DrawDiff Comparison Report

Part number: P-001 | Job: 2fd37037-1fc4-4967-b49b-15e52ceb8631 | Generated: 2026-05-05T01:34:54+00:00

ISO_LEFT [MATCHED]

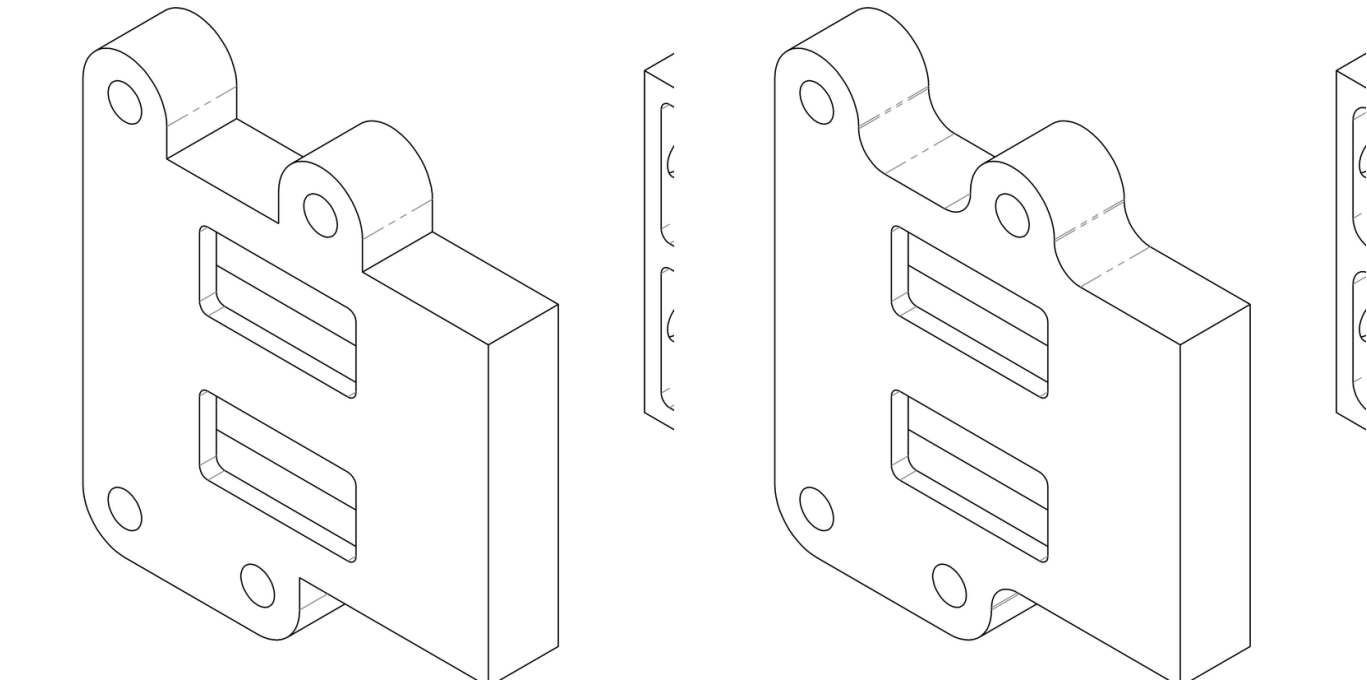
Severity	Field	Original	Revised	Conf.	Rationale
SIGNIFICANT	geometry			0.72

Severity	Field	Original	Revised	Conf.	Rationale
		Hinge knuckle/barrel area shows sharp or minimal fillet transitions between the barrel and the flat plate mounting surface	Hinge knuckle/barrel area shows larger, more pronounced fillet/radius transitions between the barrel and the flat plate mounting surface		The revised view shows noticeably larger blend radii where the hinge barrel meets the mounting plate, which would affect stress concentration, material volume, and potentially fit with mating components.

ISO_RIGHT [MATCHED]

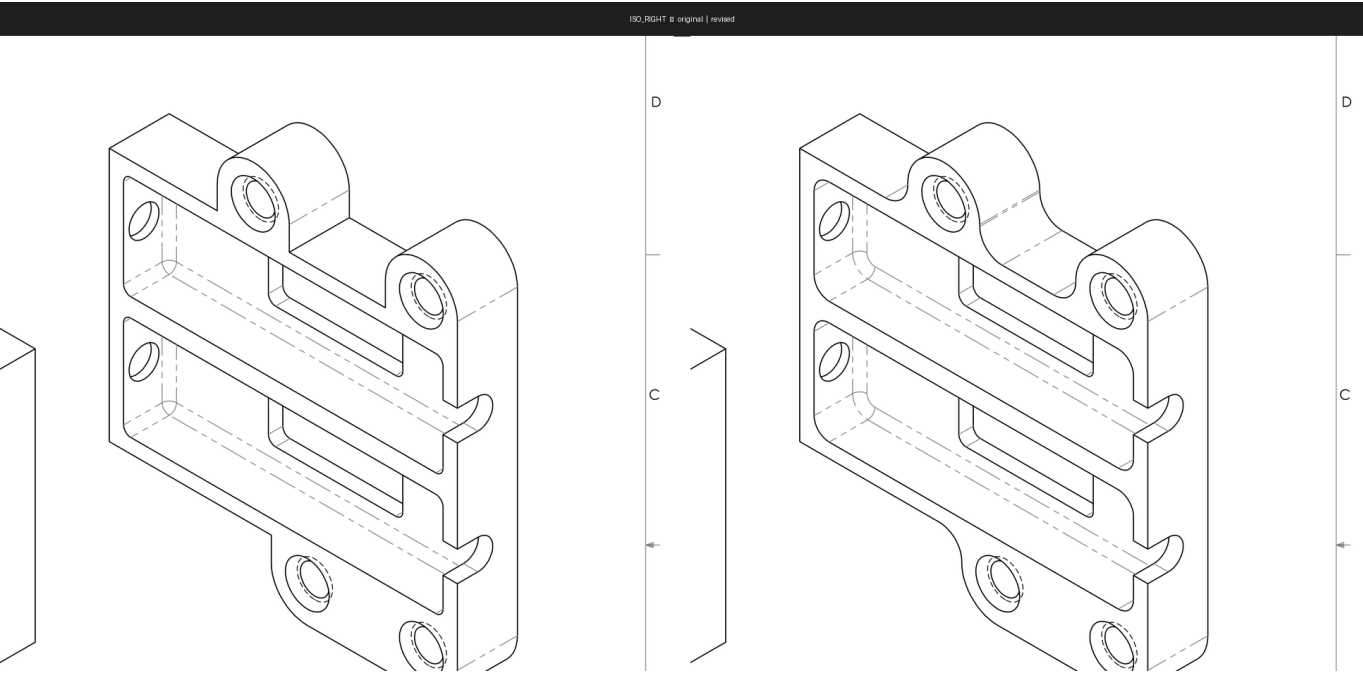
Severity	Field	Original	Revised	Conf.	Rationale
SIGNIFICANT	geometry	Sharp/angled internal corners visible on the front-left pocket walls of both upper and lower channel sections	Rounded/filleted internal corners on the front-left pocket walls of both upper and lower channel sections	0.72	The internal corner geometry of the recessed channel pockets has changed from sharp corners to radiused fillets, which affects stress concentration, machinability requirements, and potentially fit with mating components.

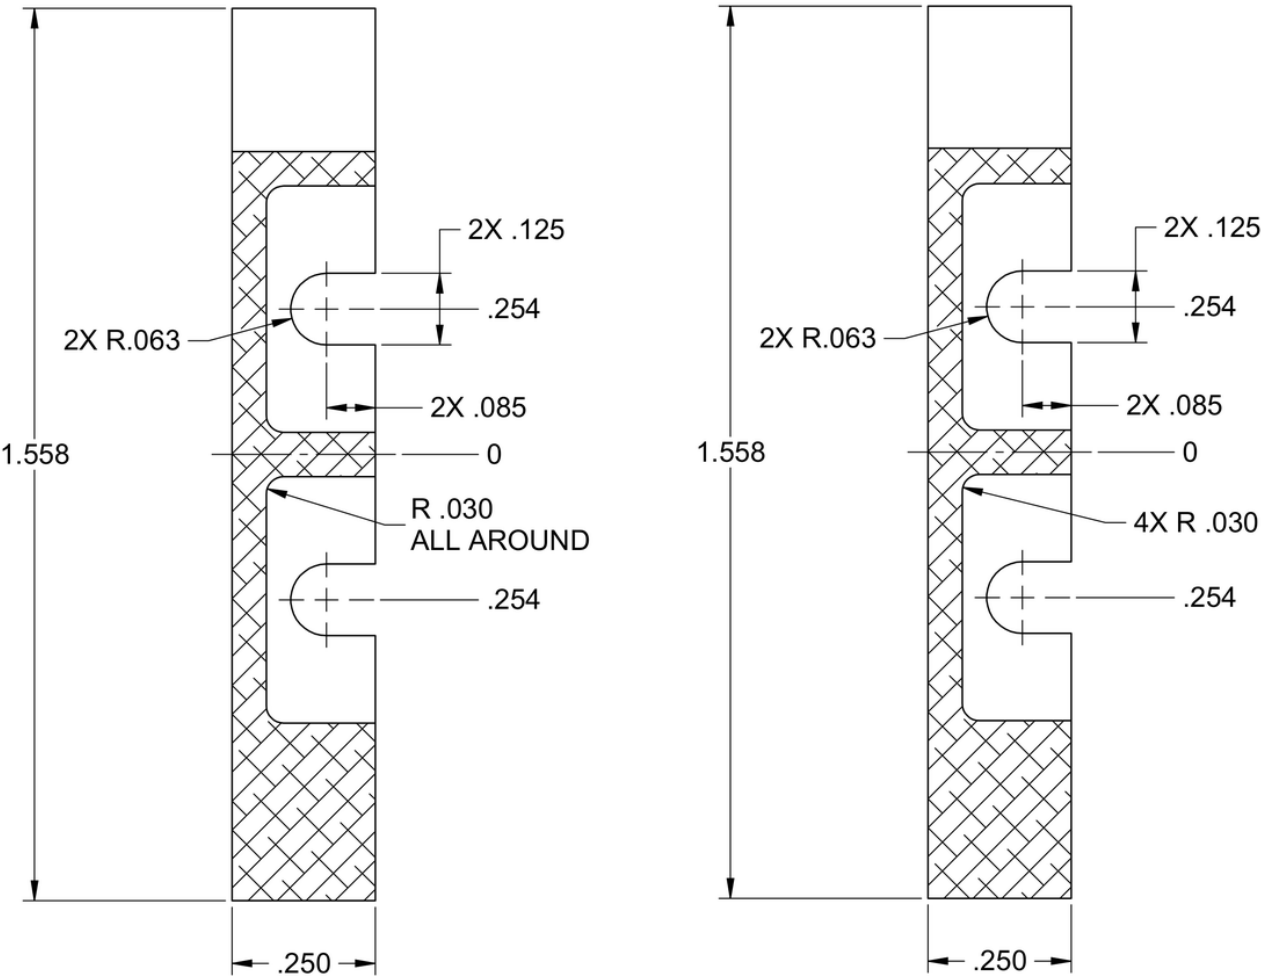
Severity	Field	Original	Revised	Conf.	Rationale
SIGNIFICANT	annotation	—	TAP	0.95	A new 'TAP' label was added to the revised view in the upper right corner, indicating a tapping operation requirement that was not present in the original drawing.
SIGNIFICANT	callout	R .030 ALL AROUND	4X R .030	0.92	The radius callout scope changed from 'ALL AROUND' (implying continuous all-around application) to '4X R .030' (explicitly specifying four discrete instances), which alters the manufacturing interpretation of where the R.030 radii are applied.

FRONT_VIEW [MATCHED]

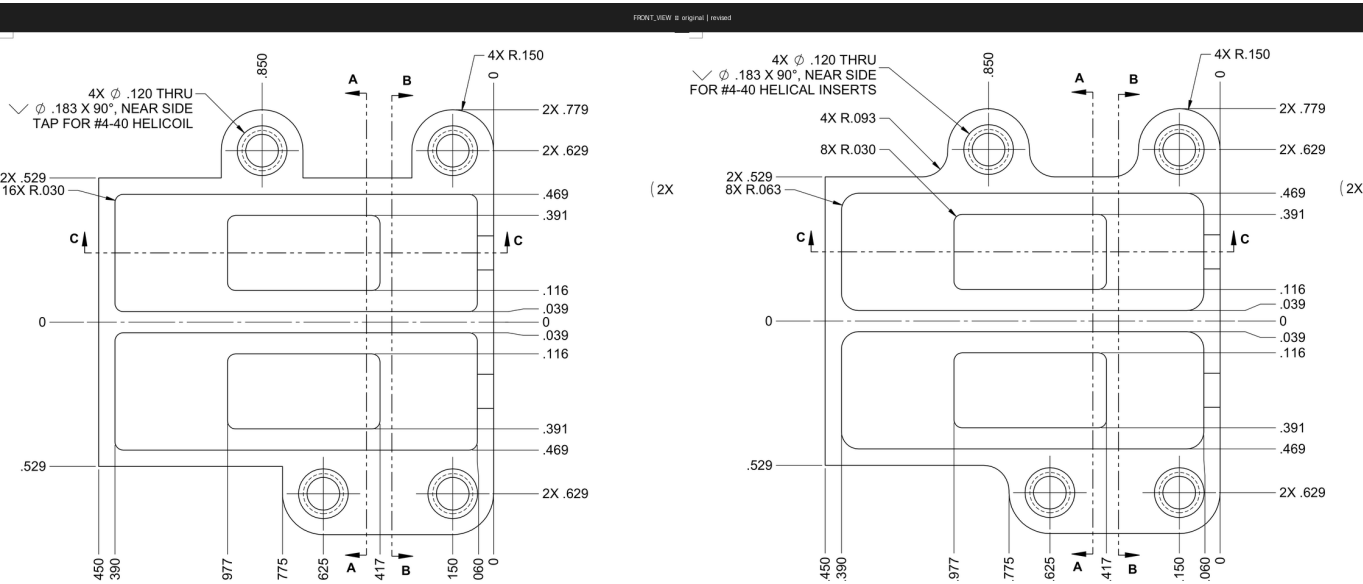
Severity	Field	Original	Revised	Conf.	Rationale
SIGNIFICANT	note	TAP FOR #4-40 HELICOIL	FOR #4-40 HELICAL INSERTS	0.92	The thread insert specification wording changed from 'HELICOIL' (brand name) to 'HELICAL INSERTS' (generic), which may affect procurement and manufacturing interpretation of the required insert type.
SIGNIFICANT	annotation	16X R.030	8X R.030	0.90	The count of R.030 radii was reduced from 16 to 8, indicating a significant change in the number of fillet/radius features on the part geometry.
SIGNIFICANT	geometry	Lower half of part shows mirrored pocket and boss features identical to upper half	Lower half of part appears simplified with different pocket/boss geometry compared to upper half	0.75	The lower portion of the part in the revised view appears to have altered pocket and boss geometry relative to the original, suggesting a functional shape change in the lower half of the component.

SECTION A-A [MATCHED]

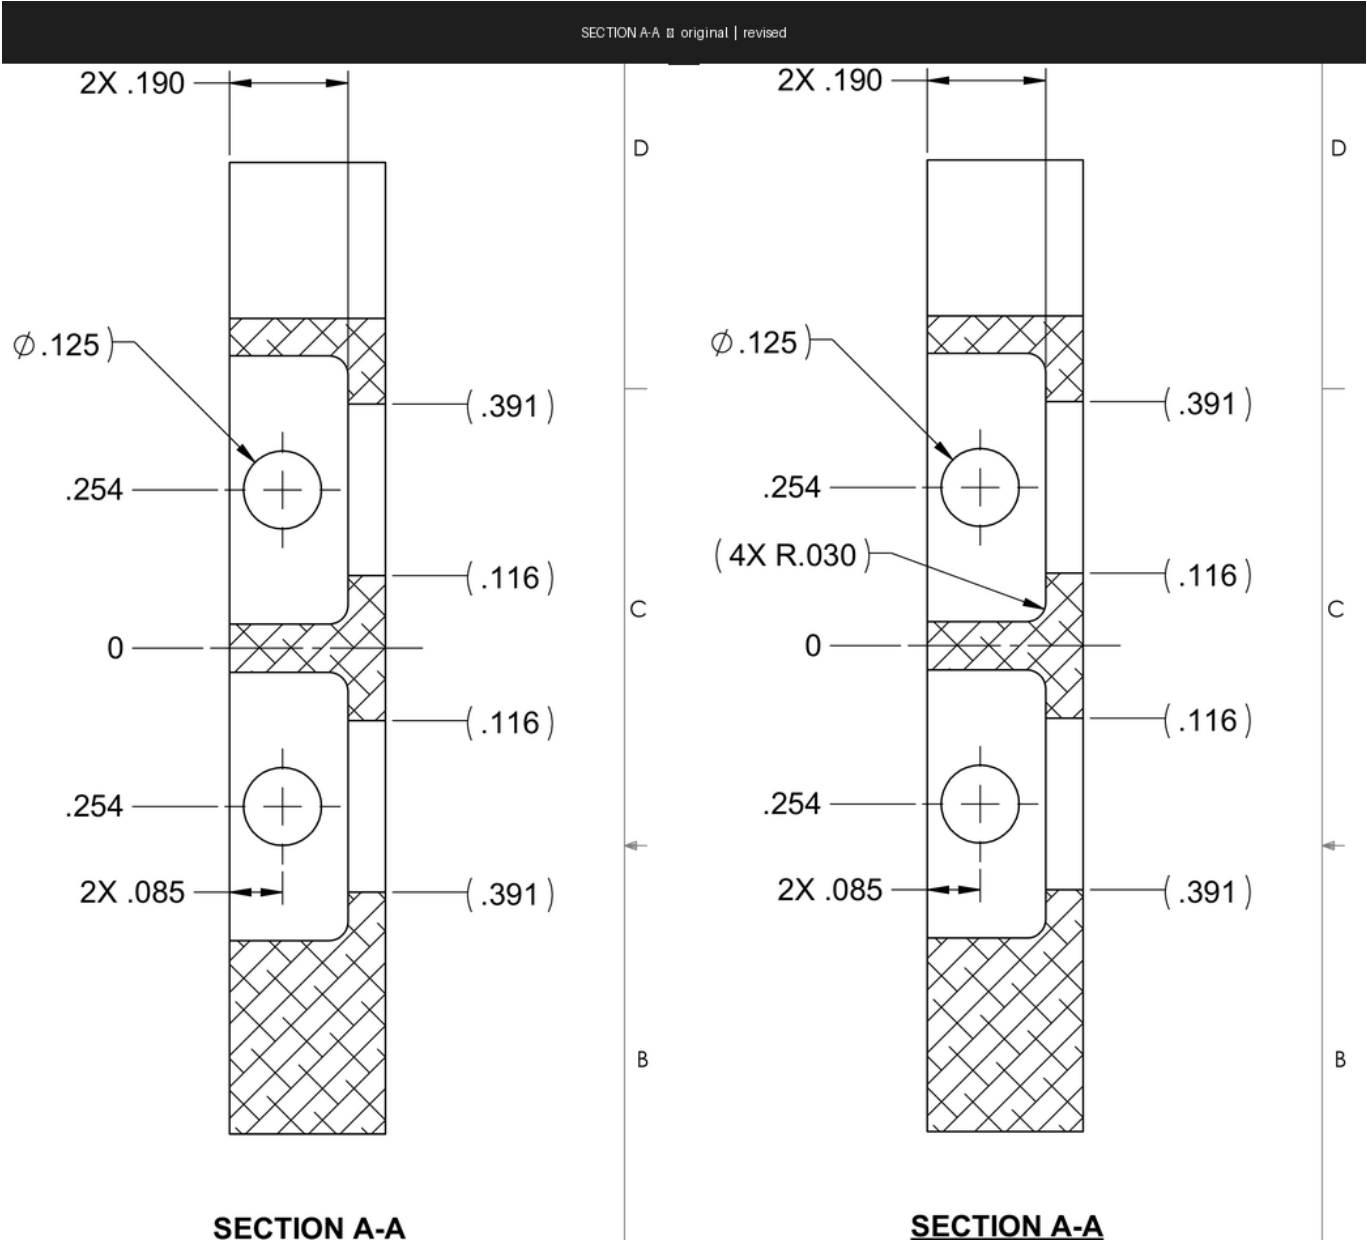
Severity	Field	Original	Revised	Conf.	Rationale
SIGNIFICANT	annotation	—	(4X R.030)	0.92	A new reference callout specifying four corner radii of R.030 has been added to the revised drawing, which defines a previously unspecified geometric feature on the slot/pocket corners and will affect machining requirements.

SECTION C-C [MATCHED]

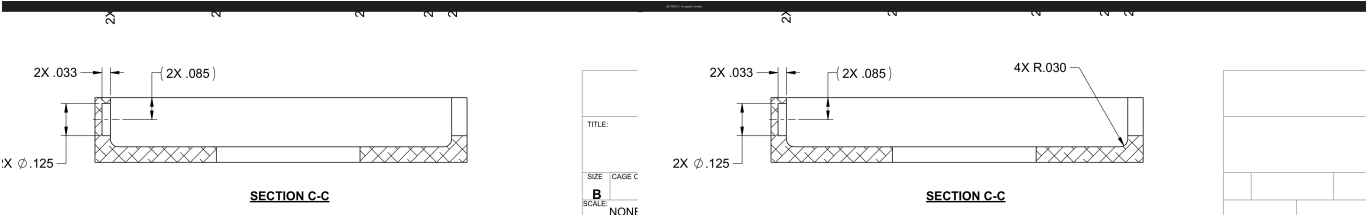
Severity	Field	Original	Revised	Conf.	Rationale
SIGNIFICANT	annotation	—	4X R.030	0.92	A new radius callout '4X R.030' has been added in the revised view, specifying corner radii that were not previously called out, which affects machining and part geometry.
